From: [Chris LaRue](#)
To: ["Ted Harberg"](#)
Cc: [Lynn Merwin](#); [Katie Allen](#); [cmocrew](#)
Subject: RE: 3rd Referral Review - ZON2025-00005 Sierra Vista Rezoning & SUB2025-00006 Sierra Vista Minor Subdivision
Date: Wednesday, February 25, 2026 4:53:00 PM
Attachments: [image001.png](#)
[image002.png](#)
[2. Avigation Review.pdf](#)
[3. Erie Airport - Manager Correspondence.pdf](#)

To: Beccah Bailey, Norris Design
From: Aly Burkhalter, Senior Planner
Date: August 21, 2025
Re: ZON2025-00005 Sierra Vista Rezoning

To: Aly Burkhalter, Senior Planner
From: Chad Schroeder, P.E., Development Engineering Supervisor
Date: August 22, 2025
Re: SUB2025-00006 & ZON2025-00005 Sierra Vista Minor Sub & Rezoning

To: Aly Burkhalter, Senior Planner
From: Nick Wagner, Transportation Engineer
Date: August 18th, 2025
Subject: Sierra Vista Minor Sub & Rezoning - Transportation Engineering Comments
CC: John Firouzi

Date: 3/6/2025	Job No: 1061-0006	Sheet: 1 of 2
----------------	-------------------	---------------

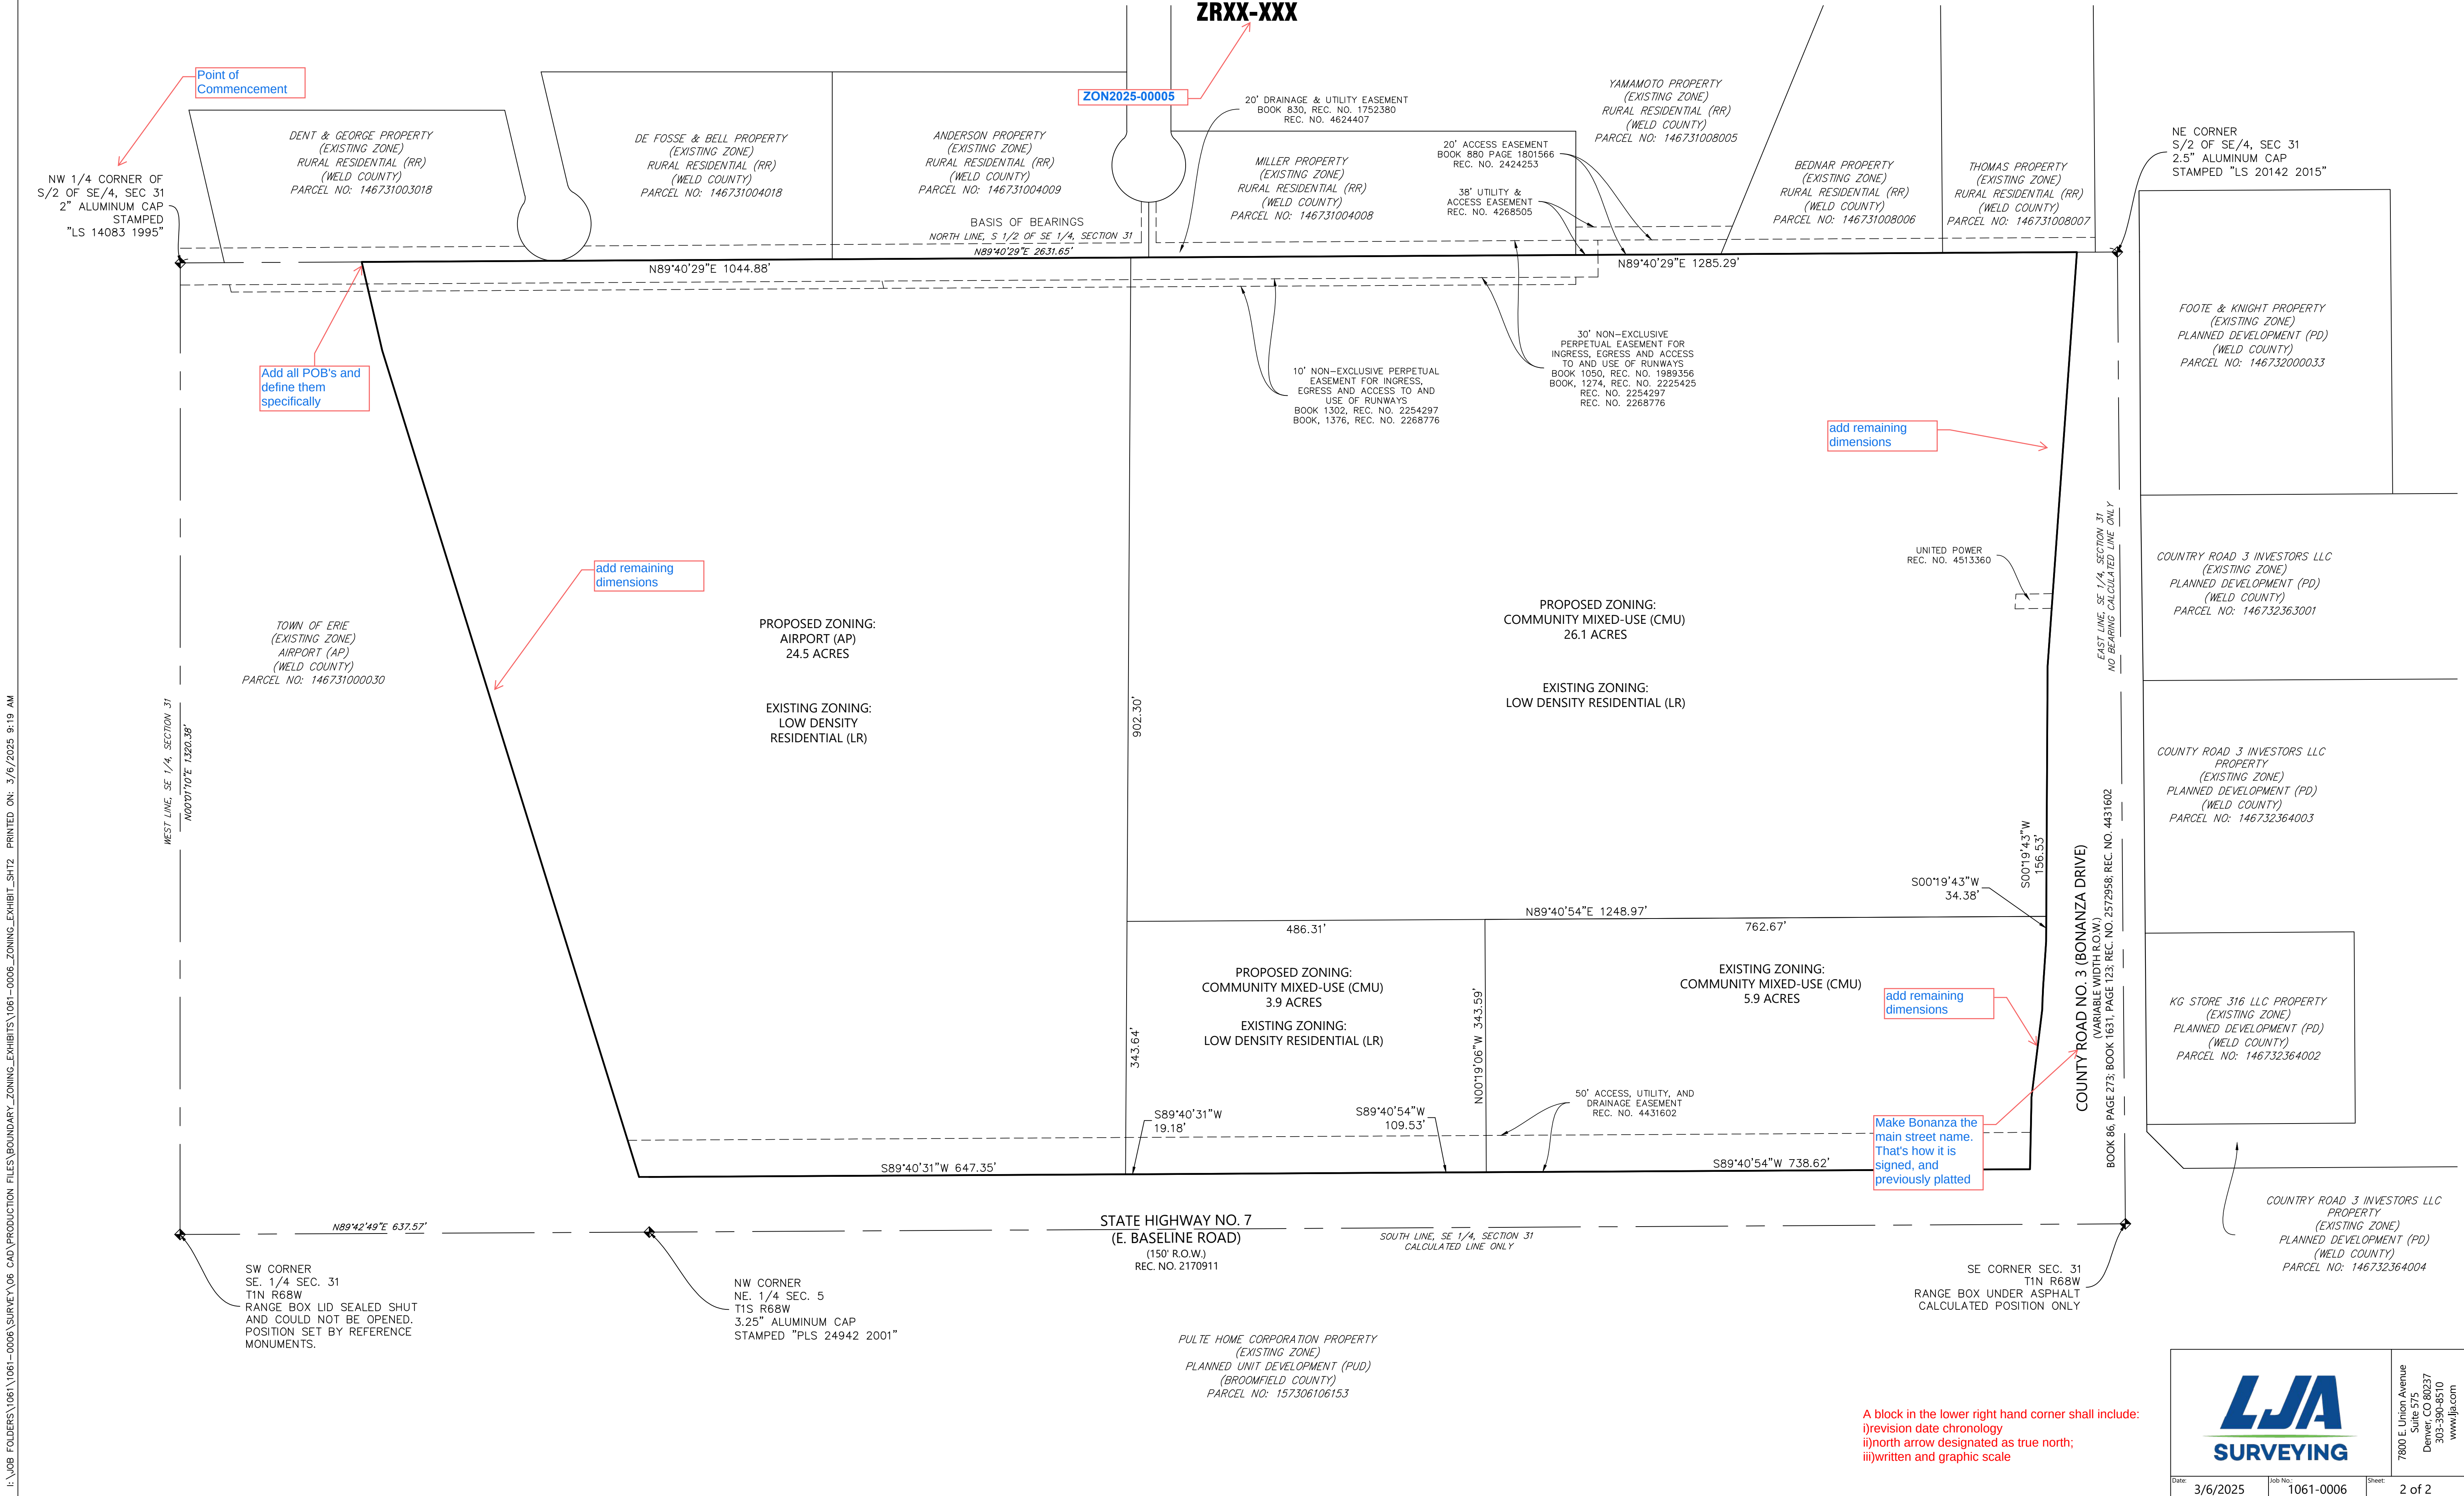
This certificate is superfluous. Weld county does not use it. Delete

A block in the lower right hand corner shall include:
i) revision date chronology

SIERRA VISTA MINOR SUBDIVISION FILING NO. 2

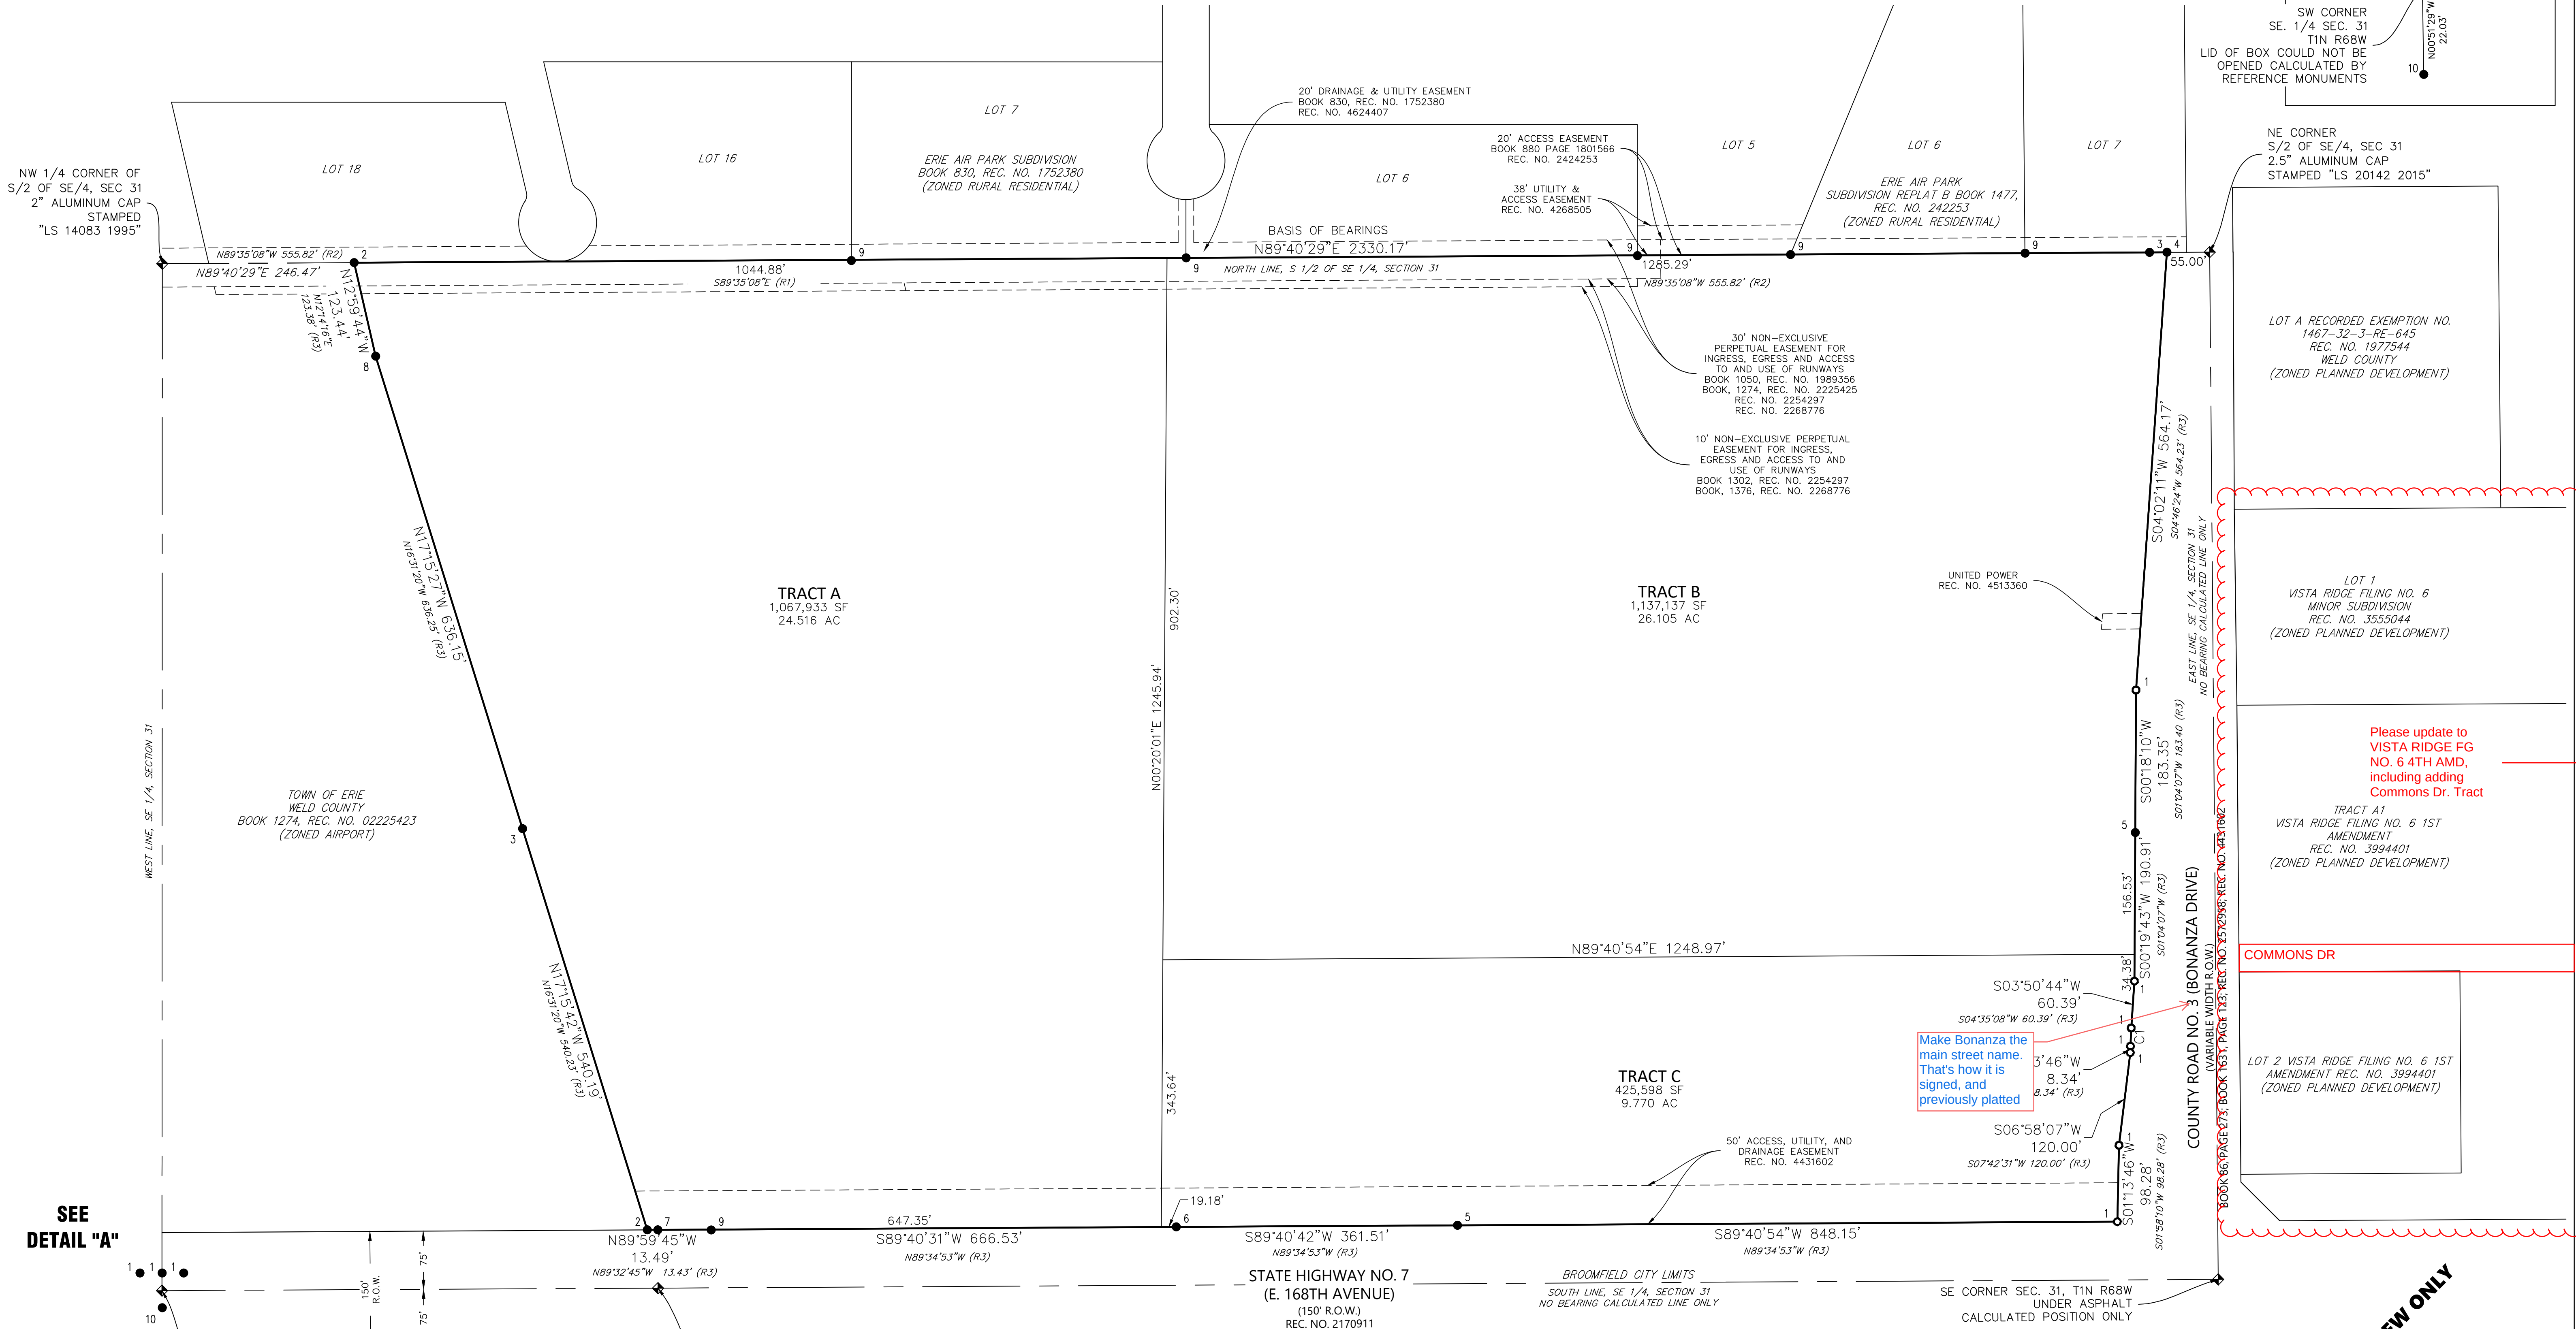
Remove. Town Council approval not required for Minor Subdivisions.

Transportation Concept Plan Comments – Provided by Nick Wagner:

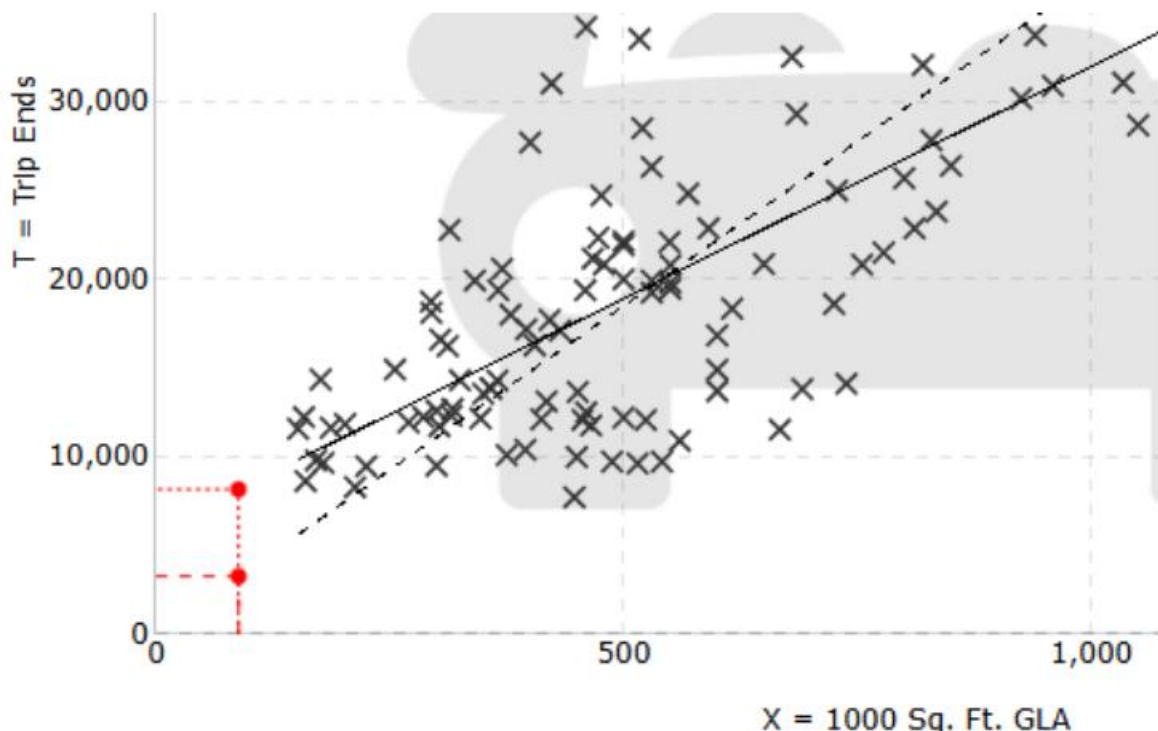
1. Remove internal site arrows/linework. At this level we would only like to see where the site entrances are being proposed as well as their movement. Any further information should come through site plans.
2. Align North site access point with the emergency access point for the ErieStorage.com building. This would put the North drive at an equal distance from Commons Dr. to the south and Sunset Dr. to the North.
3. Continue coordination with CDOT through the development process in terms of the RI/RO along HWY 7. Due to spacing with Bonanza Dr, the RI/RO might have to serve as a acceleration lane/deceleration lane, which is similar condition to Commons Way connection.

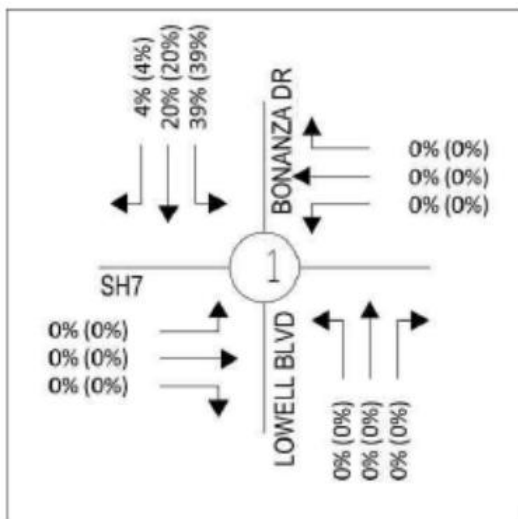
- a. Just looking at the outbound distribution suggests that the percentages are quite different from what existing traffic counts would suggest. It would be our recommendation that a more robust explanation of how trip distribution was determined should be provided in the TIA and an expectation that the distribution should better align with existing traffic counts or have excellent rationale for why they do not.

A snapshot of the ITE Trip Generation chart for Commercial/Retail (ITE 820) is shown below.

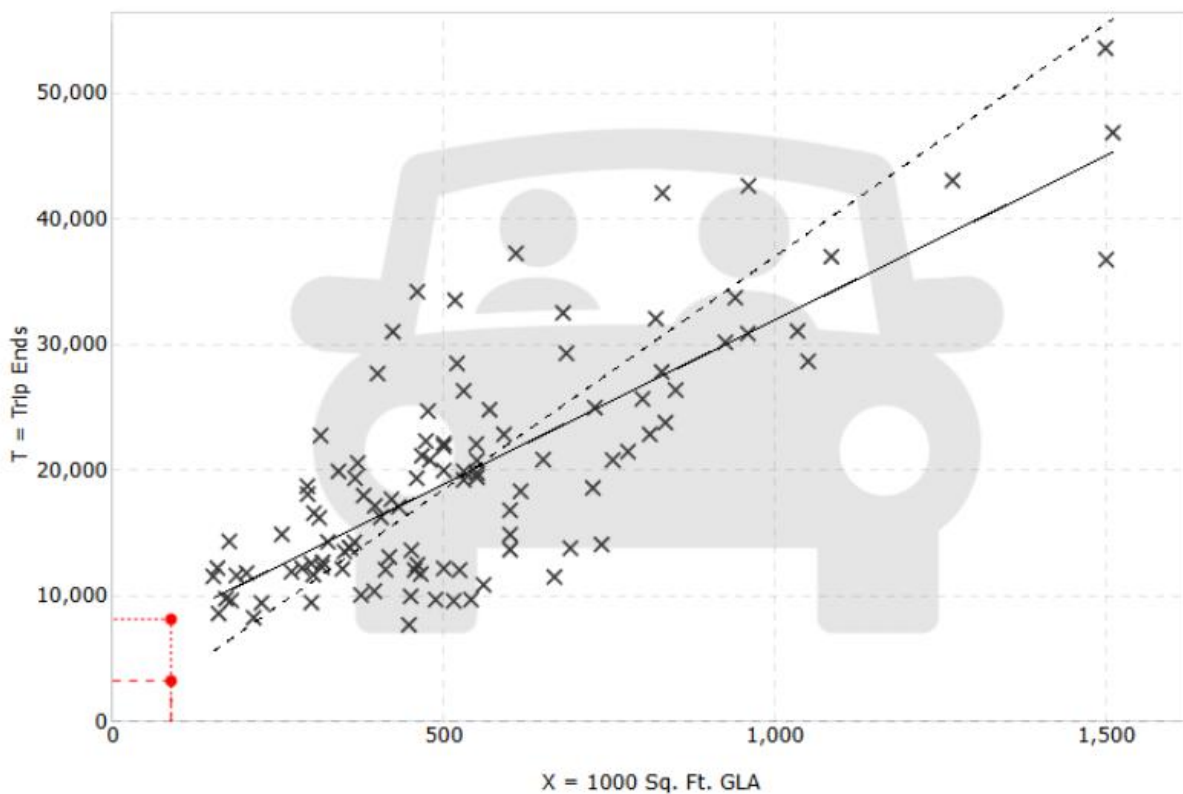
- b. The Commercial/Retail land use (ITE 820) appears to have been calculated using the Average Rate instead of the Fitted Curve. I noted in previous comments that the fitted curve seems to be the most appropriate to use given the relatively low square footage of commercial/retail here. I'll reiterate those comments below. The difference in trip generation calculated using the average rate and the fitted equations is almost 5,000 vpd, which represents a more than doubling of the trips generated by this land use.

The bottom red dot is the daily trip estimate for the commercial/retail land use using rates. The top red dot is the daily trip estimate for the same land use using a fitted curve. The difference is approximately 5,000 vehicles per day. In addition, when one looks at the data points for the studies of commercial/retail land uses closest to the size of this
